**Historic Preservation Commission Meeting**  
**Municipal Building, 625 52nd Street – Room 204**  
**Wednesday, May 1, 2024**  
**5:00 pm**

1. Certificate of Appropriateness for Exterior Alteration at 6402 Third Avenue (Emory Grant House).  
(District 3) PUBLIC HEARING

**Certificate of Appropriateness for Exterior Alteration at 6402 Third Avenue (Emory Grant House).  
(District 3) PUBLIC HEARING**

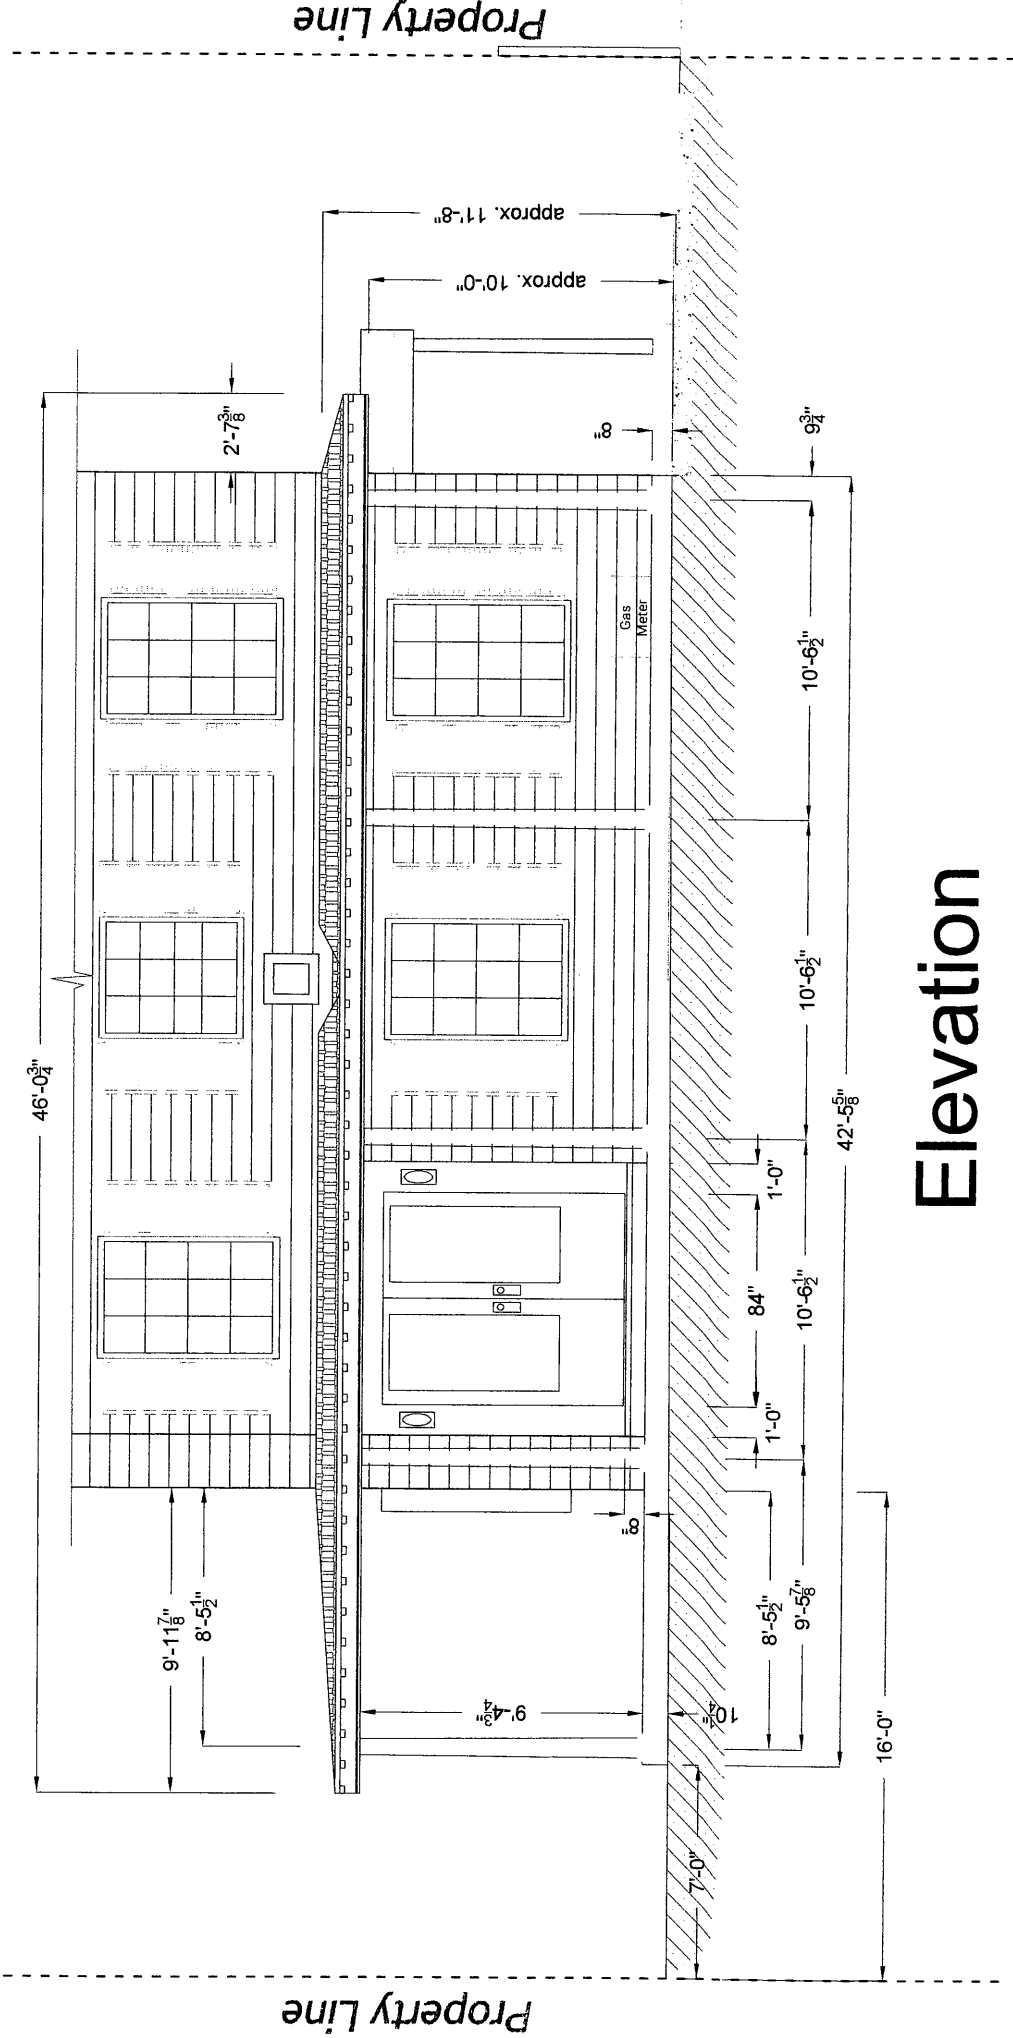
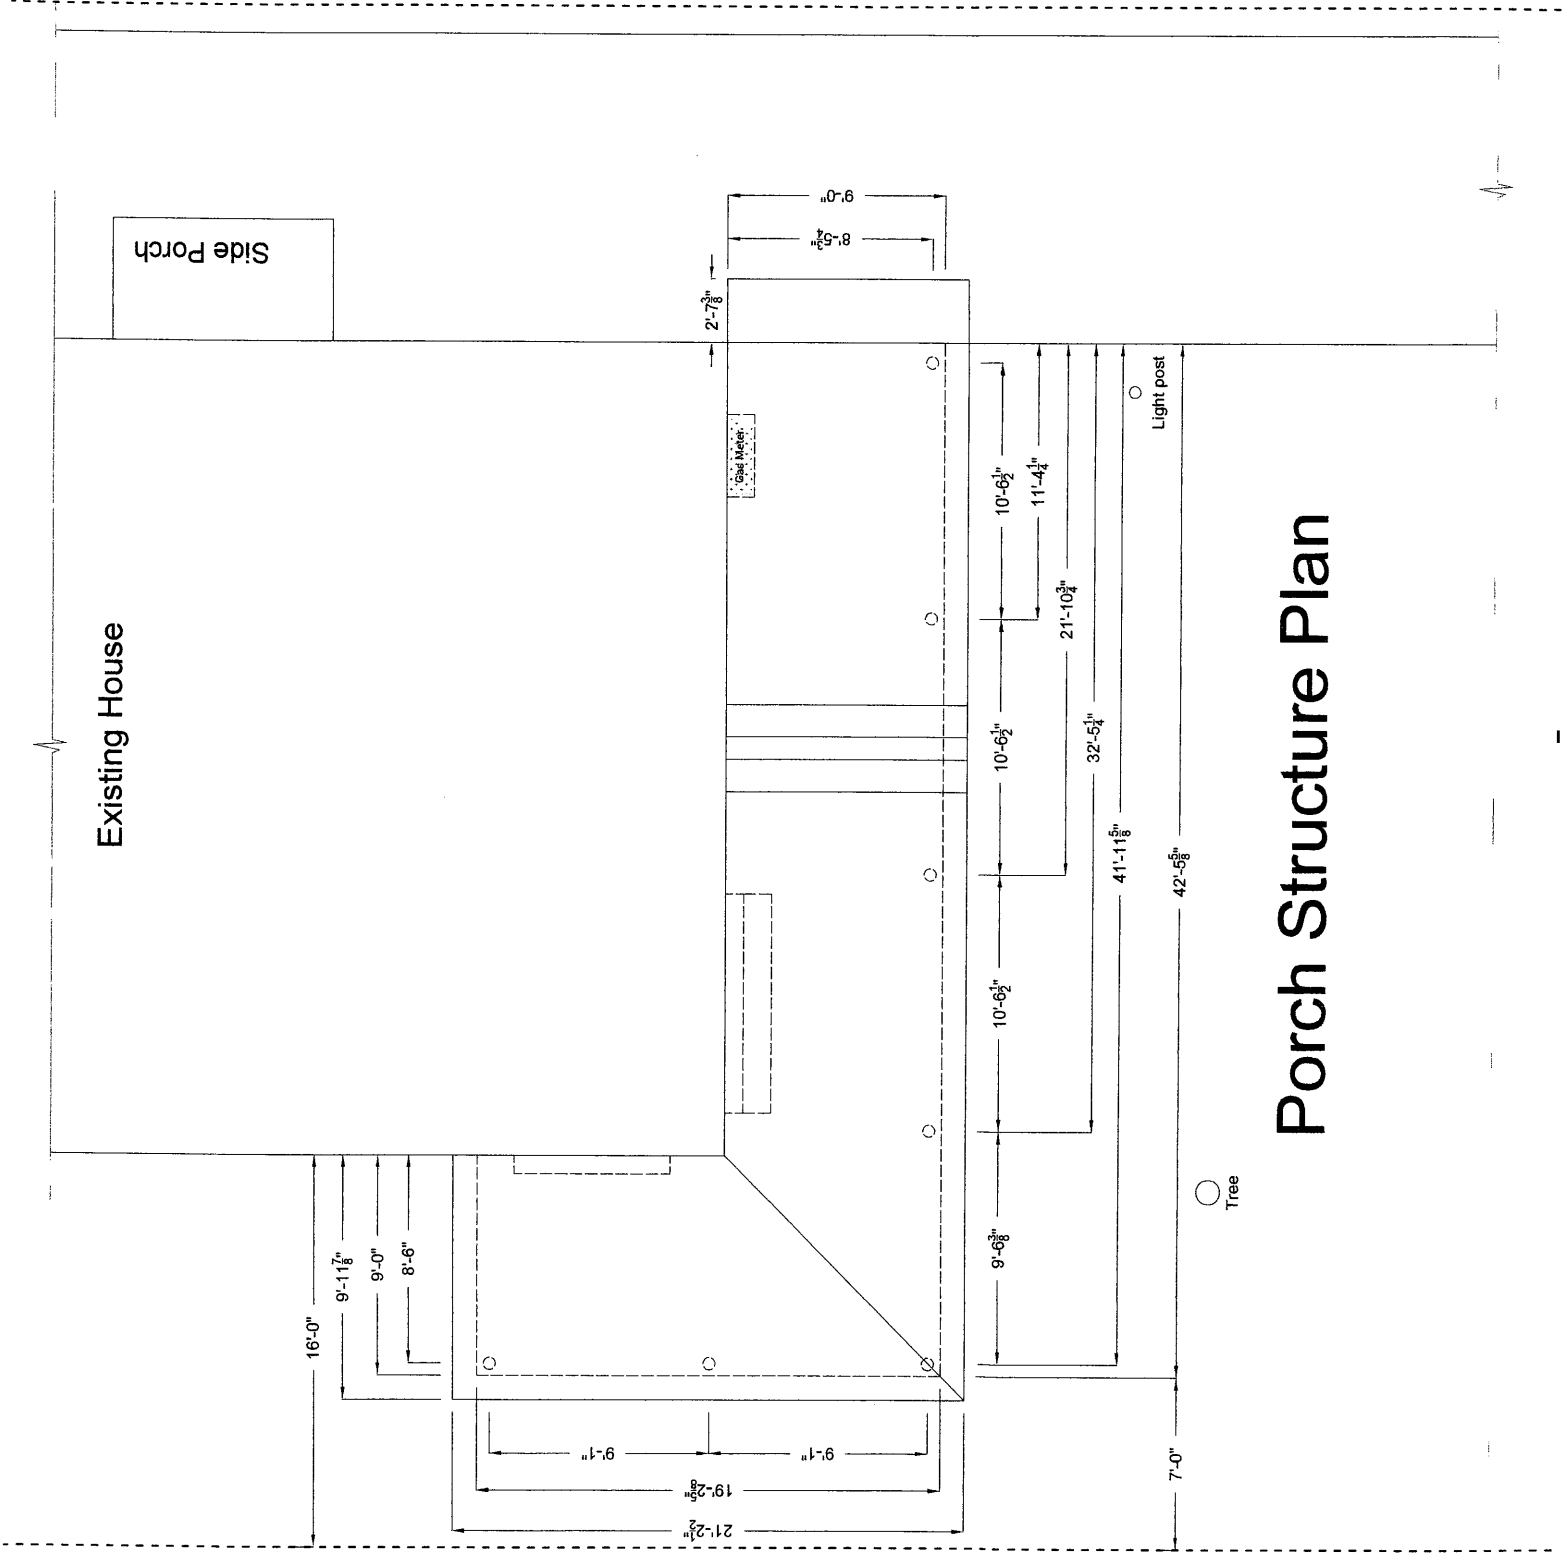
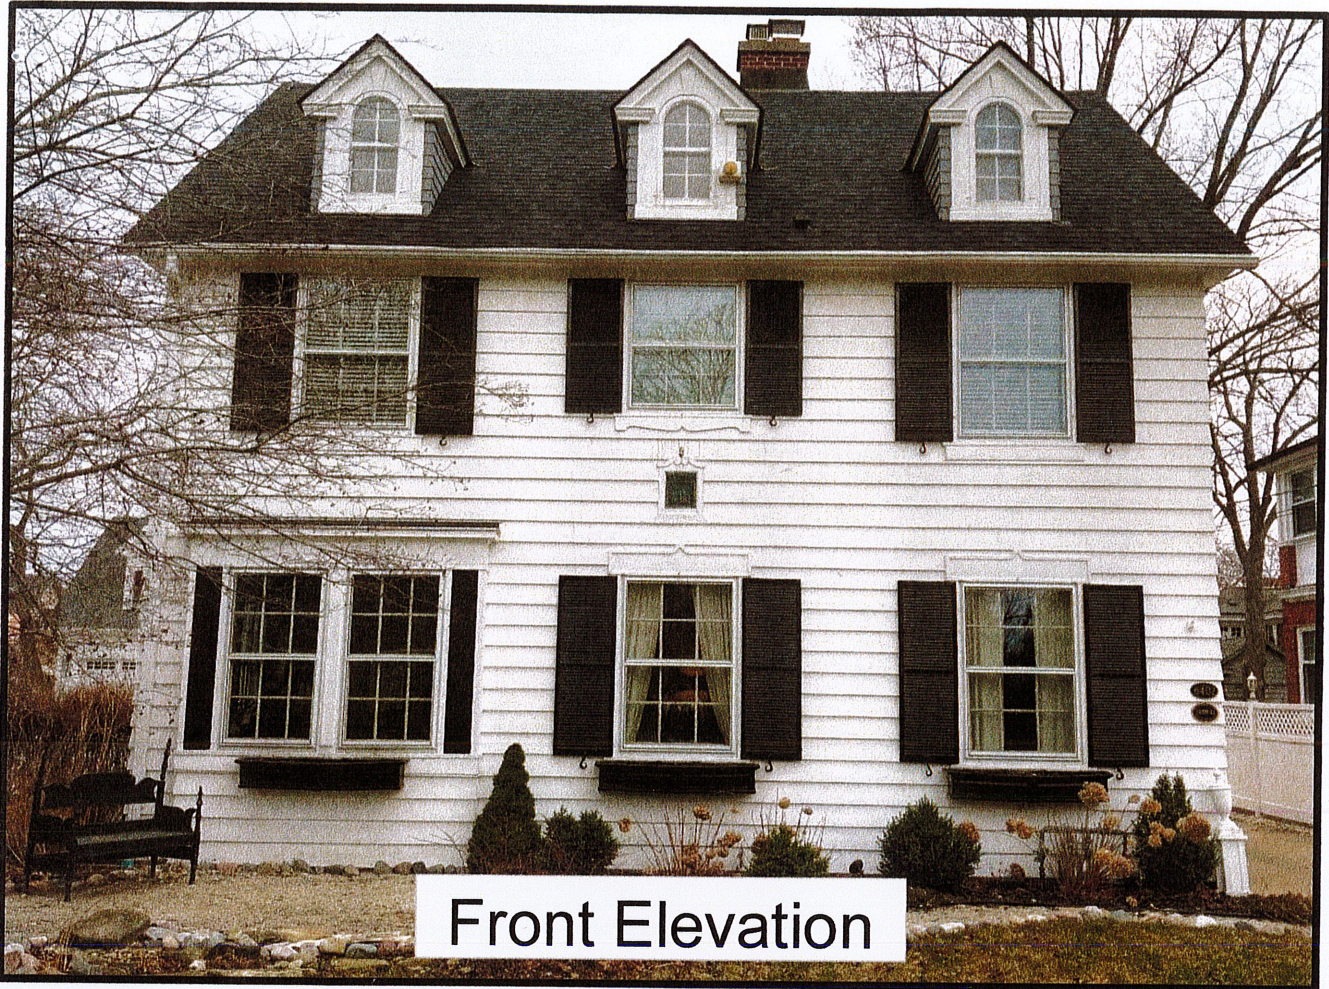
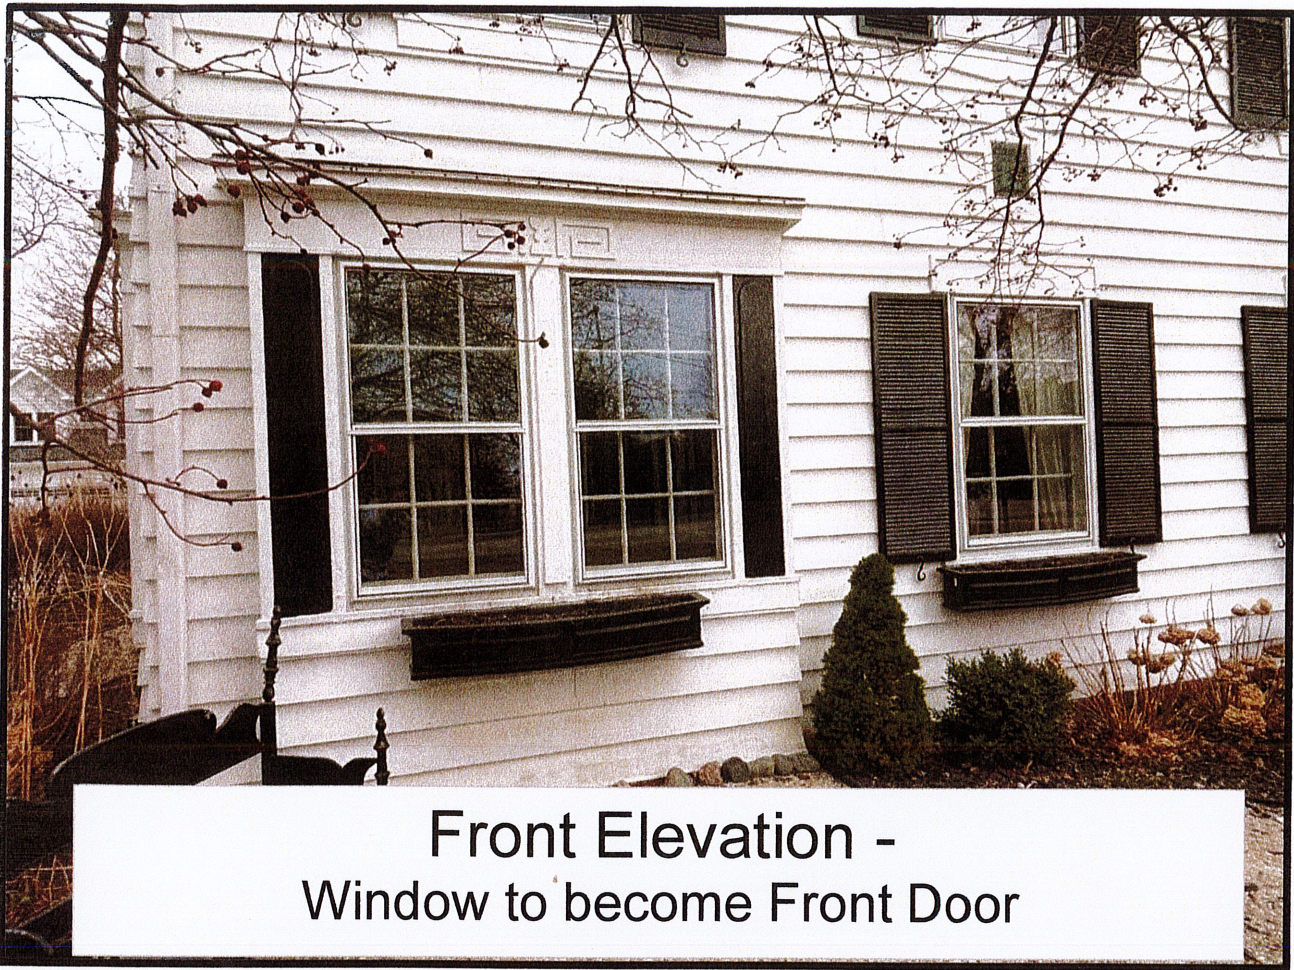
4. The current application includes:
  - a) Removal of double set of windows in bay at southeast corner of house;
  - b) Installation of double set of wood entry doors at location of windows to be removed; and,

- c) Construction of new covered porch on east elevation of house.
    - Posts to be load bearing fiberglass, painted white to match house;
    - Porch roof will be framed in lumber and painted white to match house;

- Shingles will be black to match house roof shingles;
    - Porch ceiling will be beadboard painted light blue or clear natural stain; and
    - Porch floor will be concrete with exterior edge as band of cream city brick.

- b) The Emory Grant house is atypical since the primary entrance is located on the north side of the home, there is a bay with two windows on the southeast corner of the home with one window directly above and there is another bay with three windows on the south elevation with one window centered above.

- c) The proposed double door entry, while not normally recommended, preserves the width of the existing bay with two window openings.
  - d) The proposed covered porch is compatible with the materials and scale of the existing home.

A recommendation is made to approve the Certificate of Appropriateness for exterior Alteration of the Emory Grant House per Section 15.10 D. of the Zoning Ordinance for the City of Kenosha, the Third Avenue Historic District Preservation Plan and general compliance with the Secretary of the Interior's Standards and Guidelines for Alteration.
